Access Compliance Report

Public Rights-of-Way

(Curb Ramps)

Intersection ID: 2698	Main Street: GRABURN'S_FORD_DR	Cross Street: HIGHLAND_CREEK_PY	Location: NW
ADA ID: 35C4111A9F71	Ramp Type: Perp	Initial Pass/Fail: Fail	Overall Compliance: No
Severity Score: 21.25			
Codes/Mitigation Info/Possible Solution		Field Measurements/Component Compliance

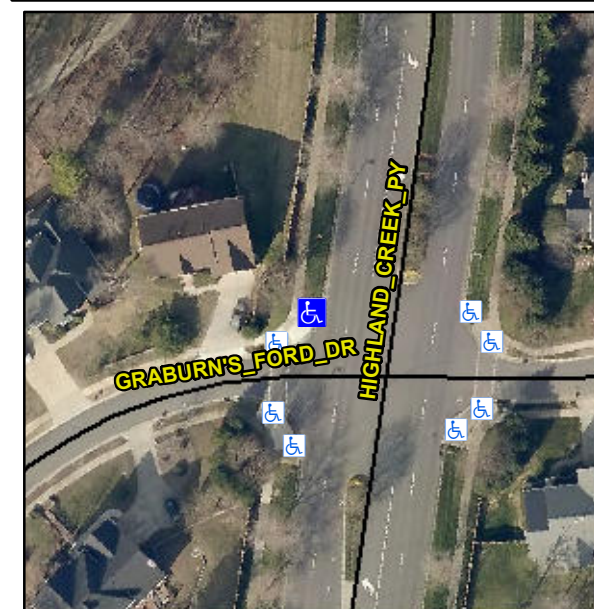
R304.5.1, R304.5.3

Compliance	Description	Data	Compliance	Description	Data
N/A	Ramp Length (in)	124.5	Yes	Ramp Slope (%)	5.7
No	Ramp Width (in)	36.5	No	Ramp XSlope (%)	5.8
N/A	Flare Type LT	N/A	N/A	Flare Type RT	N/A
N/A	Flare Slope LT (%)	N/A	N/A	Flare Slope RT (%)	N/A
N/A	Flare Traversable LT?	N/A	N/A	Flare Traversable RT?	N/A
N/A	Landing Length (in)	N/A	N/A	DWS Provided?	N/A
N/A	Landing Width (in)	N/A	N/A	DWS Contrast?	N/A
N/A	Landing Slope (%)	N/A	N/A	DWS Length (in)	N/A
N/A	Landing X Slope (%)	N/A	N/A	DWS Full Width?	N/A
N/A	Landing Curb? (Y/N)	N/A	N/A	DWS Offset (in)	N/A
N/A	Shared Landing?	N/A			
N/A	Gutter Ponding?	N/A	N/A	Gutter Slope (%)	N/A
N/A	Gutter Lip Ht (in)	N/A	N/A	Gutter X Slope (%)	N/A
N/A	Painted X Walk1?	No	N/A	Painted X Walk2?	N/A
	X Walk 1 Direction	To E		X Walk 2 Direction	N/A
N/A	X Walk 1 Width (in)	N/A	N/A	X Walk 2 Width (in)	N/A
	X Walk 1 Slope (%)	3.3		X Walk 2 Slope (%)	N/A
	X Walk 1 X Slope (%)	5.3		X Walk 2 X Slope (%)	N/A

Remove & Replace Entire Ramp.
